MEMORANDUM

Project: Allied Drive Development

Re: Reply Comments to UDC

AlliedDrive Neighborhood Redevelopment

0' 4' 8' 16' SCALE: 1/8" = 1'-0" Building B Elevations July 1.2008

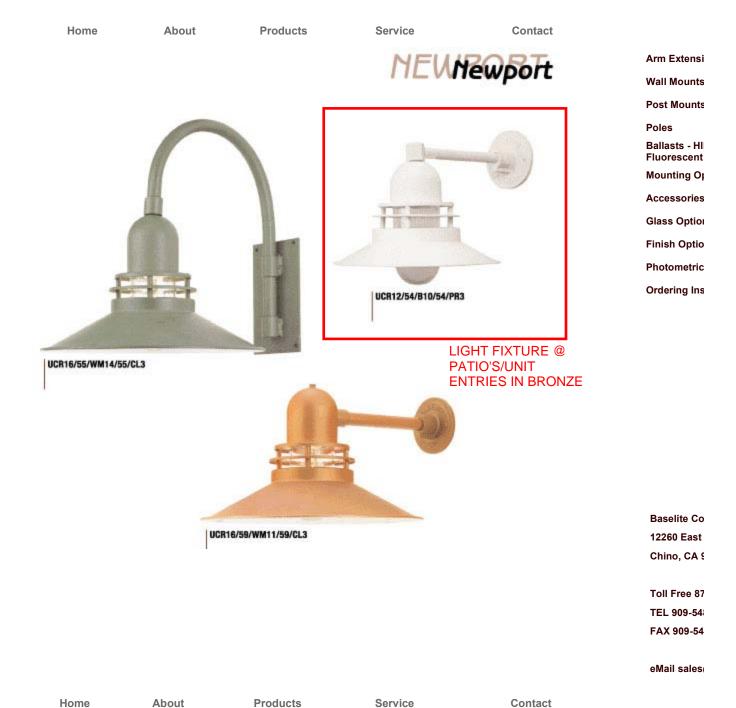
Comment 8 - Glass has been added to the north end of vestibule on Building B.

NEIGHBORHOOD REDEVELOPMENT PLAN - BUILDING E

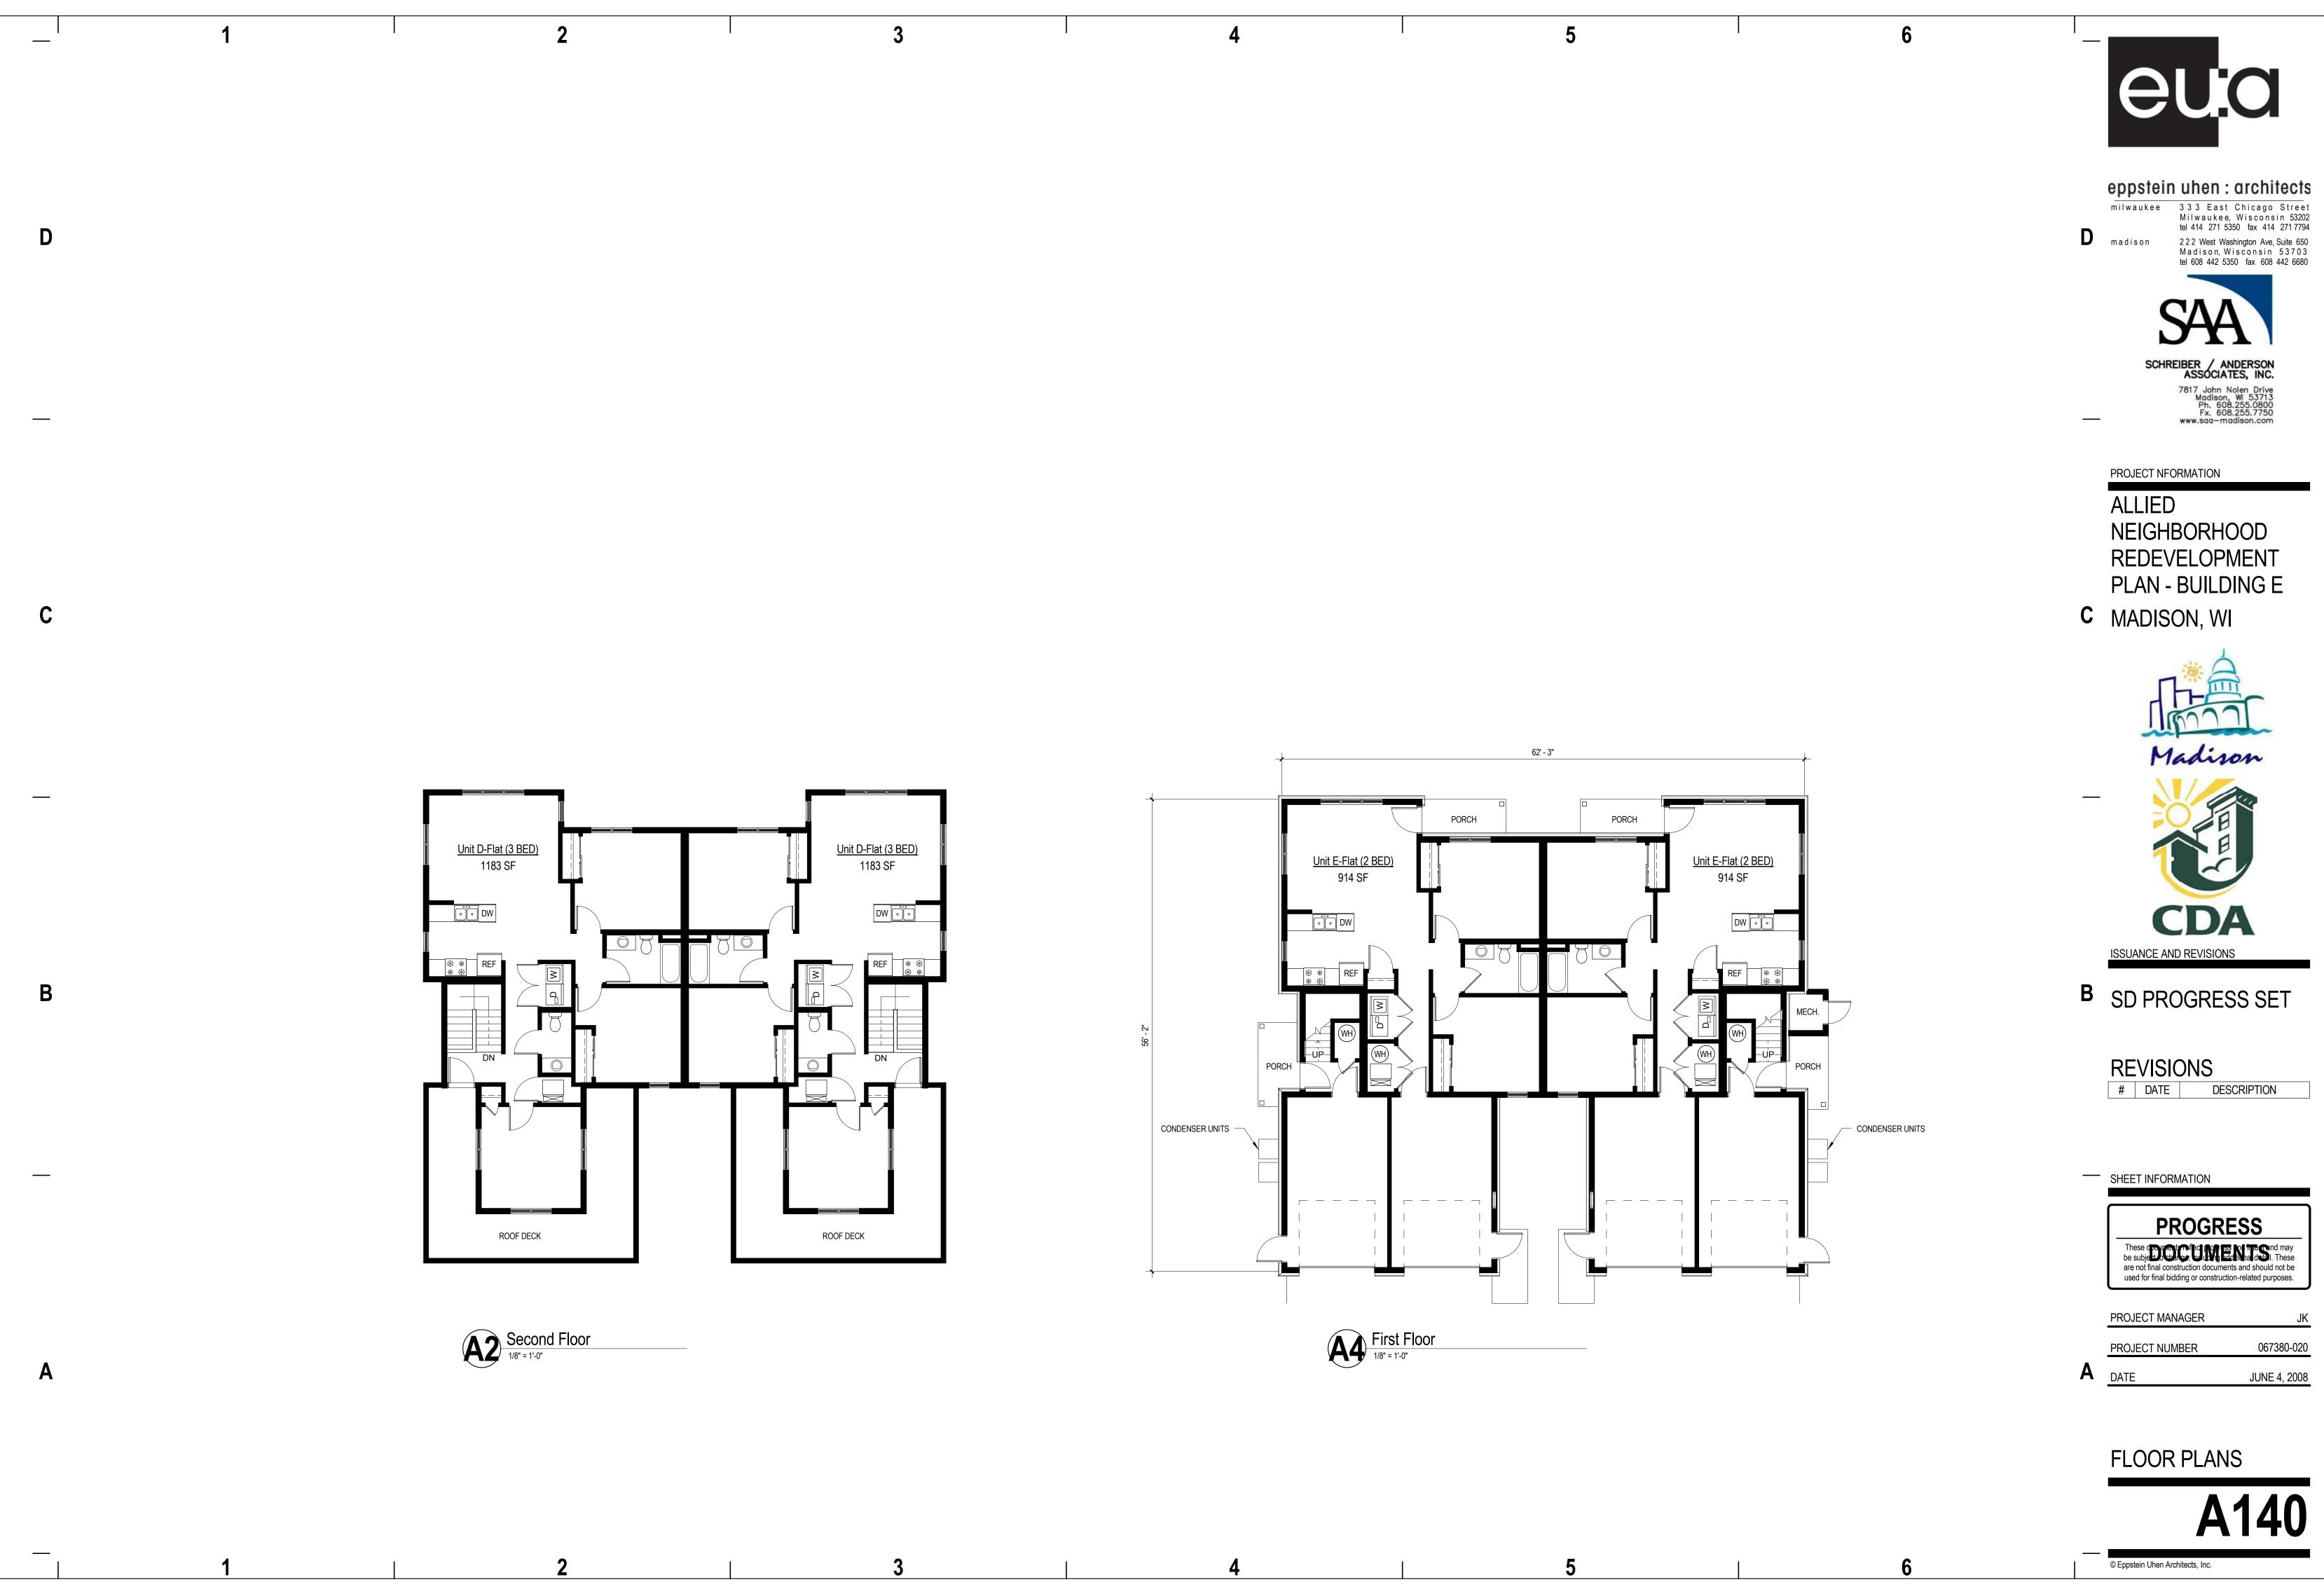
Comment 4 – The sloped and flat roof condition on the low rise buildings will be detailed properly with ice and water shield up sloped and vertical walls so that flat roof area can be drained properly. A downspout and scupper box will be installed to drain the roof area.
